HISTORIC LANDMARK COMMISSION
APPLICATION FOR A CERTIFICATE OF APPROPRIATENESS
AUGUST 7, 2024
HR-2024-077497
ROGERS-WASHINGTON-HOLY CROSS HISTORIC DISTRICT
2305 EAST 21ST STREET

Construct an accessory dwelling unit.

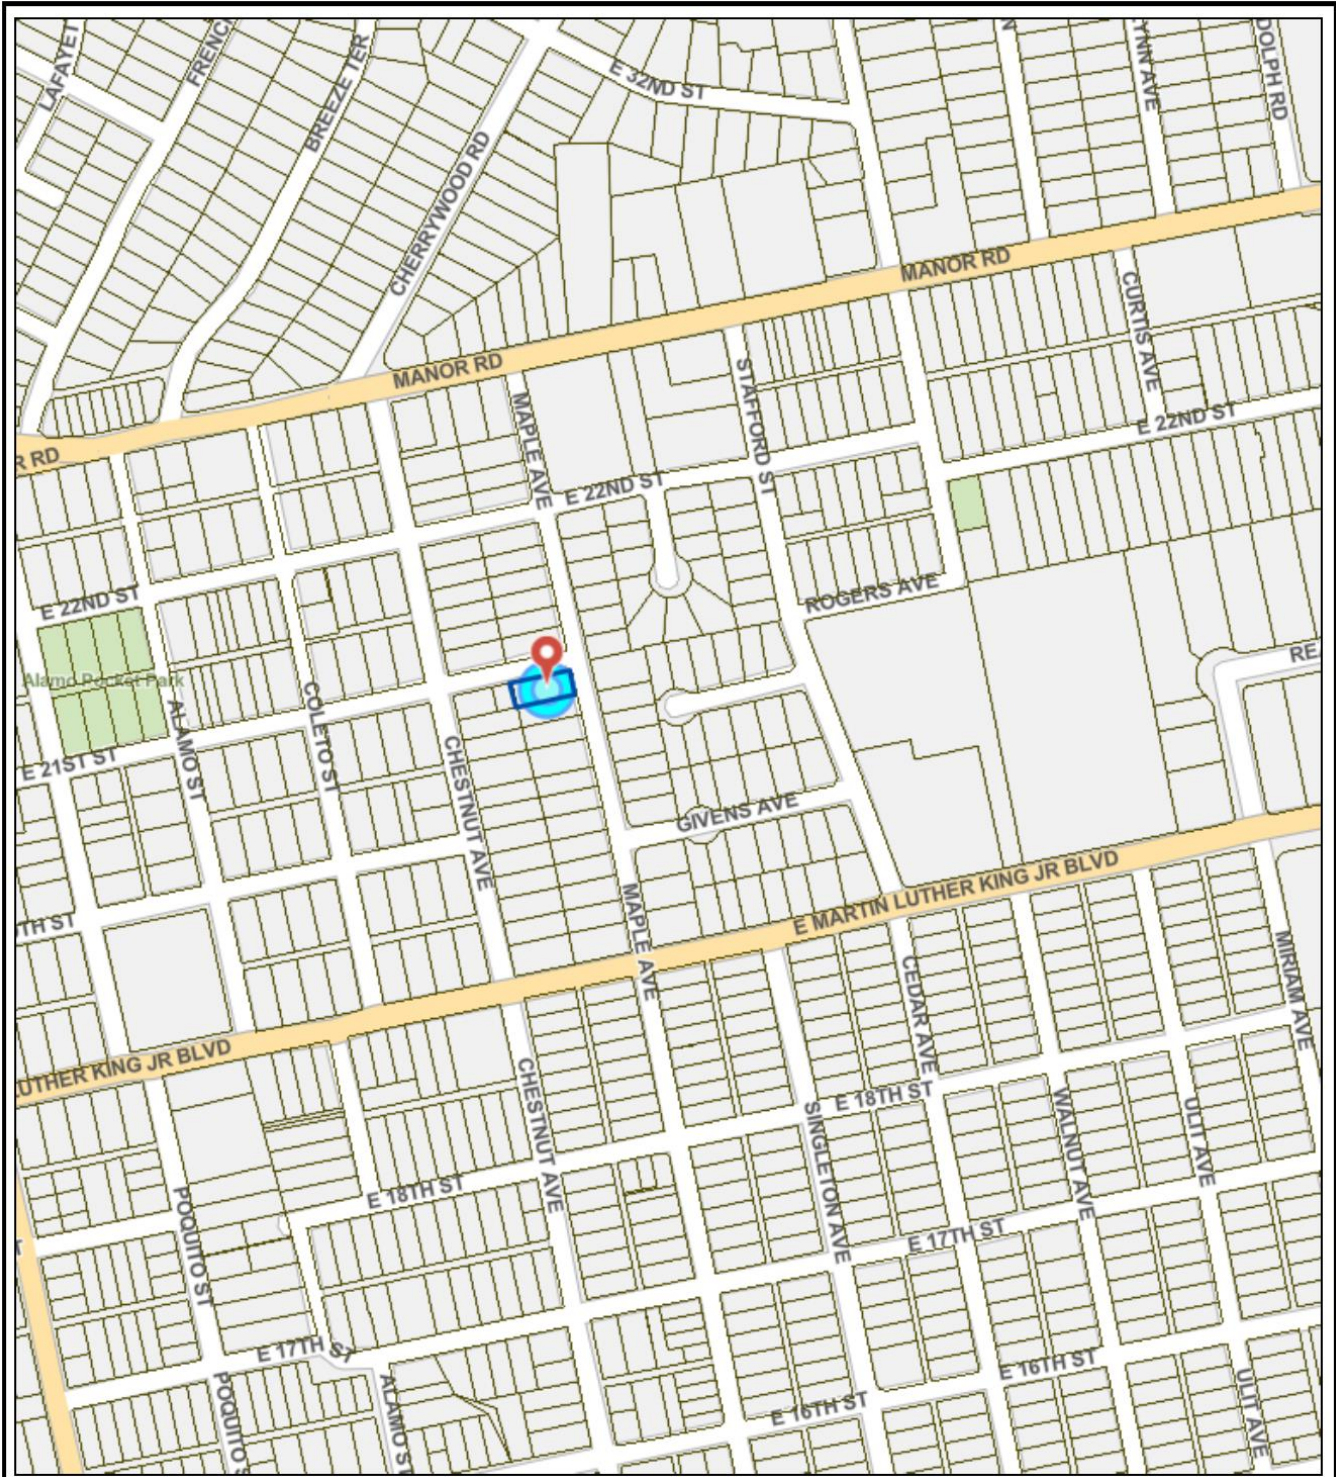
The dimensions of the proposed windows do not match the proportions of the square front windows of the historic house,

especially on the ground floor where they intersect with the brick skirt. The orientation of windows on the rear and sides of the house do not reflect any sort of pattern and are vertical in orientation, different from anything that is found on the original home and uncommon in similar contributing houses in the district.

The proposed single front door is narrow compared to the front door of the original home but is appropriate in glazing and surround. There is not a language of symmetry found in the district and is also not present in this design.

Approve the application with the recommendation that the fenestration be simplified on the sides and rear of the ADU, and that the awning over the front entryway be redesigned. Alternatively, postpone to the September 4, 2024 HLC meeting and invite the applicant to the next meeting of the Architectural Review Committee scheduled for August 14, 2024.
